Subject: Docket No. 50-206
Systematic Evaluation Program
San Onofre Nuclear Generating Station
Unit 1

Information Pertaining to SEP Topic VI-1,
Organic Materials and Post Accident Chemistry

Information Needed to Determine Deviation
from Current Licensing Criteria for
Combustible Gas Control Inside Containment
SEP Topic VI-5

LOCATION SAN ONOFRE NUCLEAR GEN. STATION
P & I DIAGRAM
AIR CONDITIONING SYSTEM
SOUTHERN CALIFORNIA EDISON COMPANY
LOS ANGELES, CALIF.

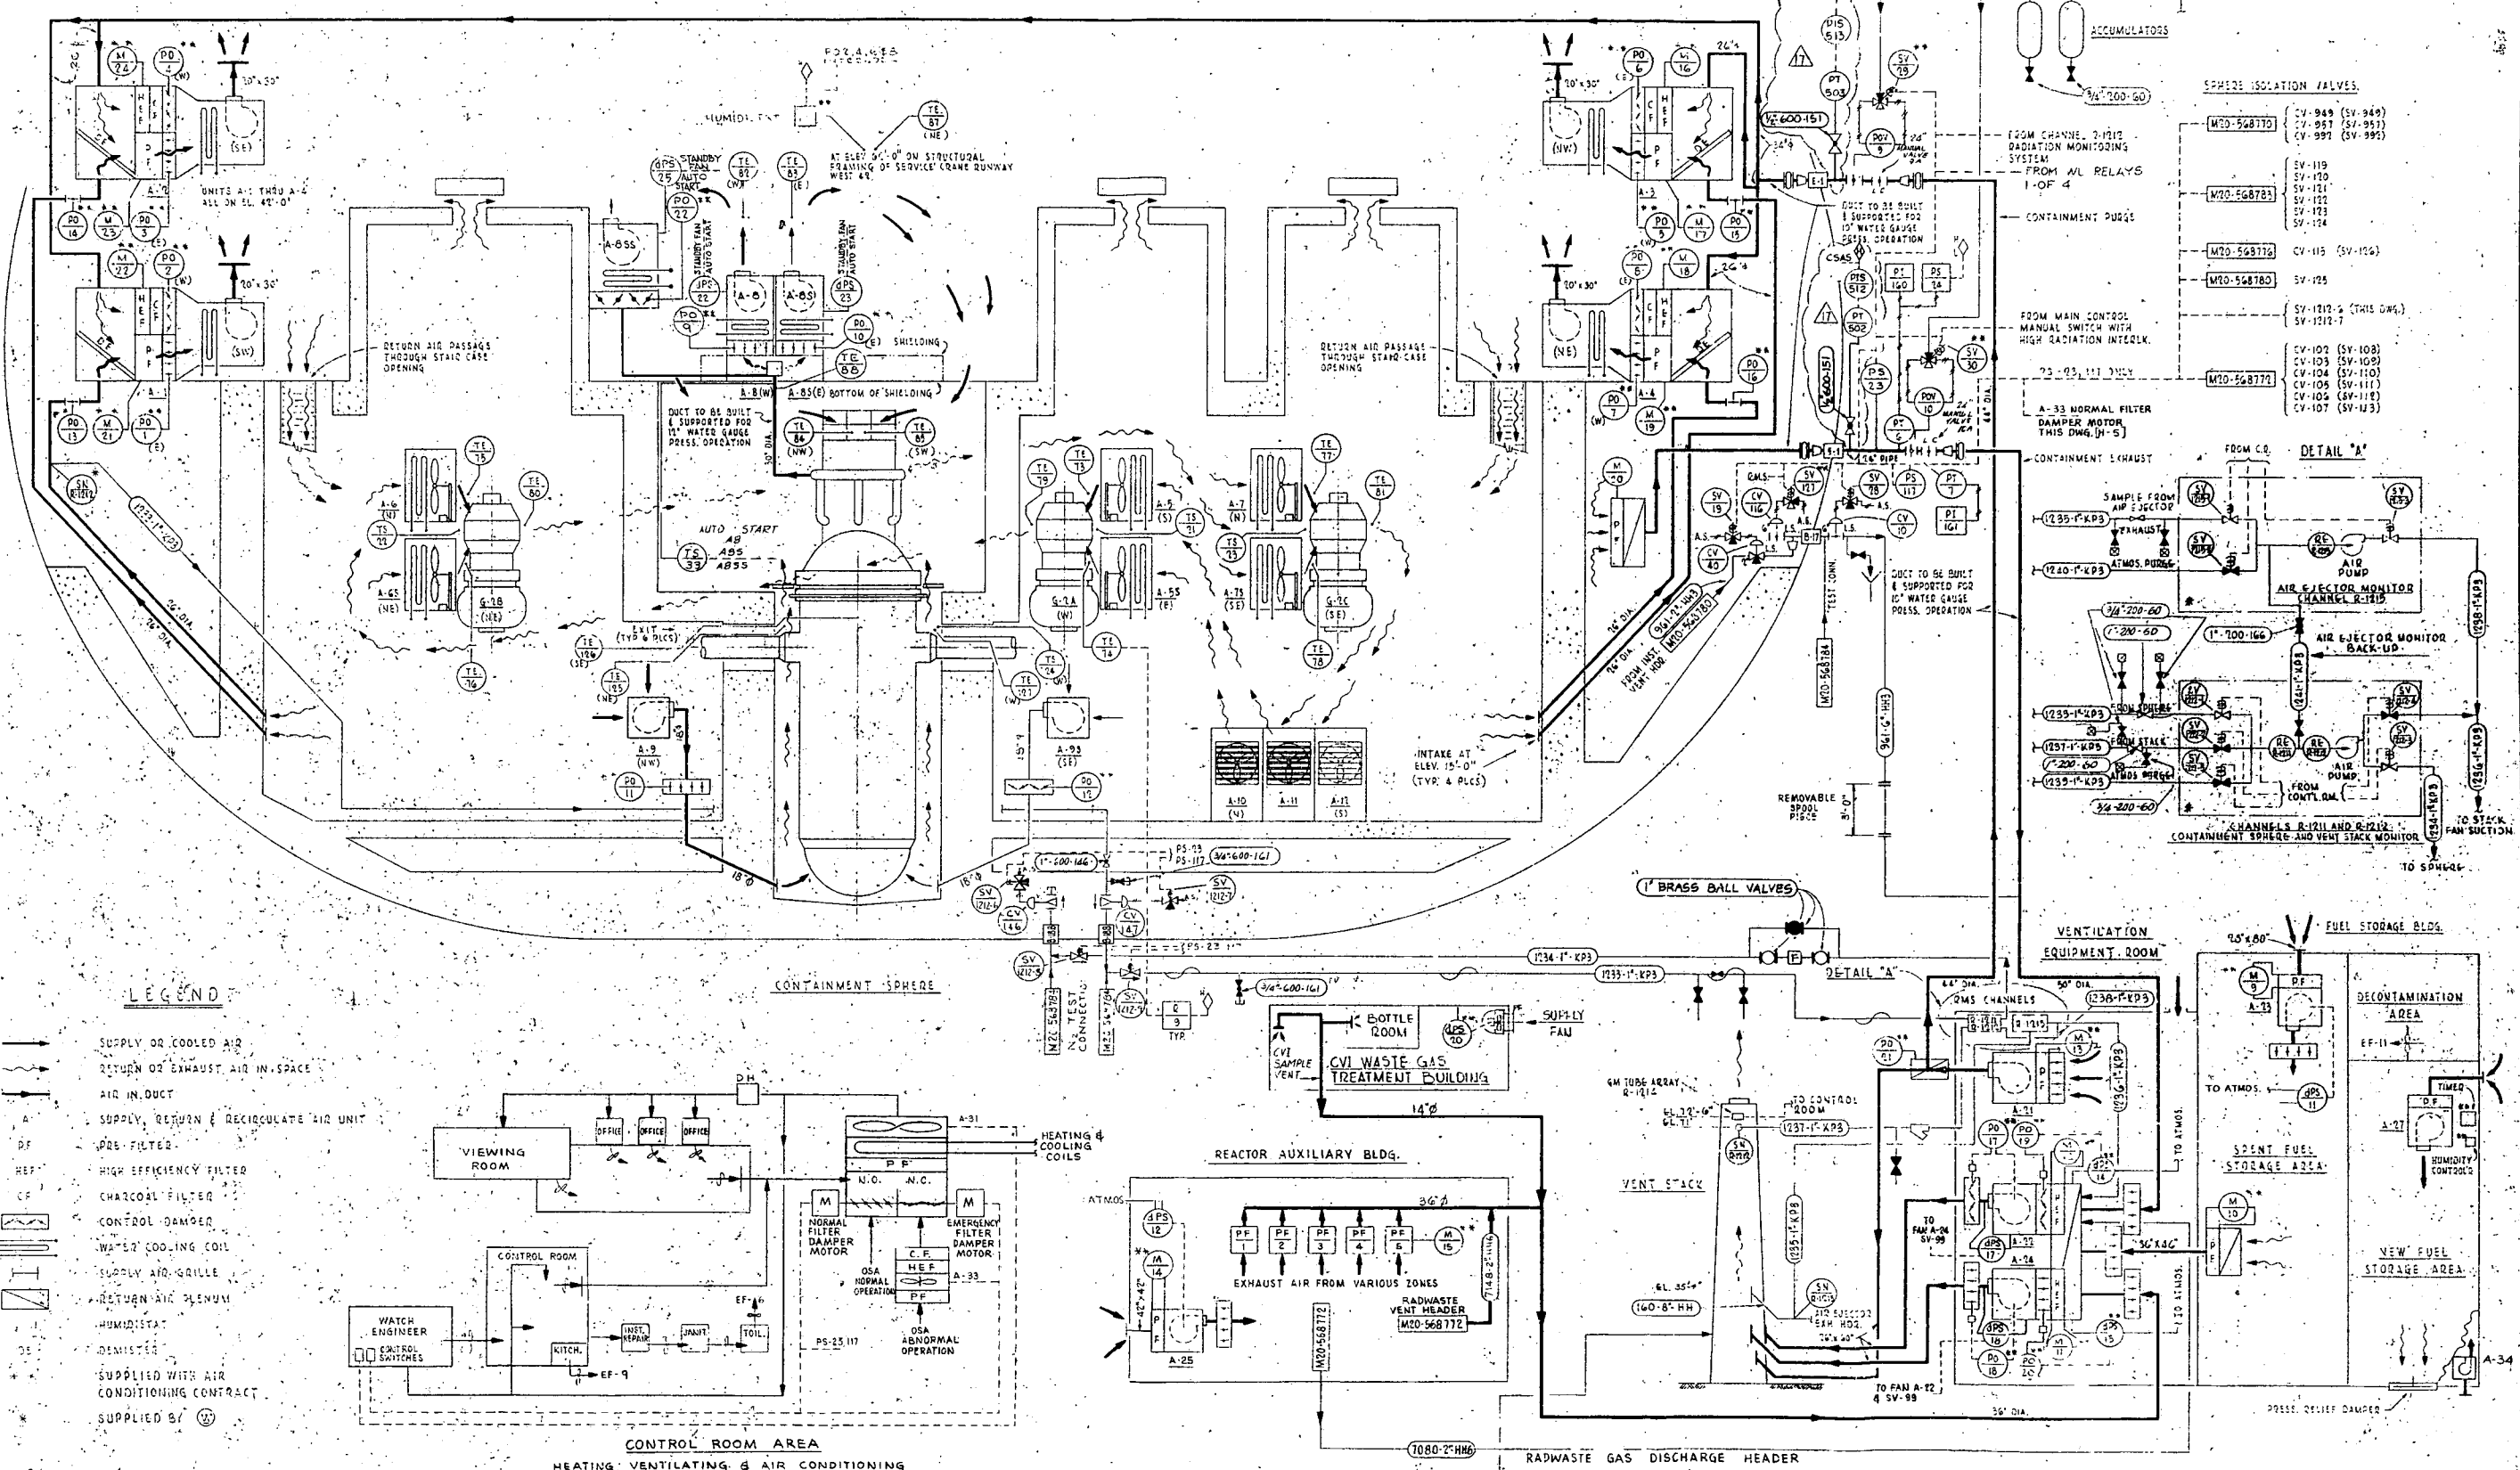
1. At the time of the design and construction of Unit 1, there were no specific combustible gas control requirements in effect. For this reason, San Onofre Unit 1 does not have a system specifically designed to mix, monitor and control combustible gas concentrations. However, there is equipment in place which could be used for these functions. This equipment is included as part of the containment air conditioning system; is shown on P&ID 568782-18 and is described in part below.

The containment atmosphere is mixed by the Containment Sphere Cooling and Filtering System. There are four identical units. Each unit (A1 through A4) takes suction at elevation 15'-0" and discharges air horizontally at elevation 42'-0". Return air flows down two access stairways to the 15'-0" elevation. Each unit has a capacity of 5000 cfm. Each unit is not single failure proof. However, no single failure will affect all four units. The power supply for each unit is:

2. The duct work required to remain intact for atmospheric mixing is shown on P&ID 568782-18. Failure of any single duct would reduce, but not eliminate mixing since there are three other redundant, independent units. Ducts were designed to industrial standards in use at that time.
3. As discussed above, there is no on-site equipment for analyzing combustible gas. Provisions can be made to sample containment atmosphere through line 1233-1"-KP3. This sampling flow path is independent of the other equipment used to mix or purge combustible gas.
4. The potential sources of hydrogen formation inside containment are aluminum, zinc and the stainless steel fuel cladding. The total weight of stainless steel cladding is approximately 21,452 lb., assuming the total fuel length. If only the active fuel length is considered, there is approximately
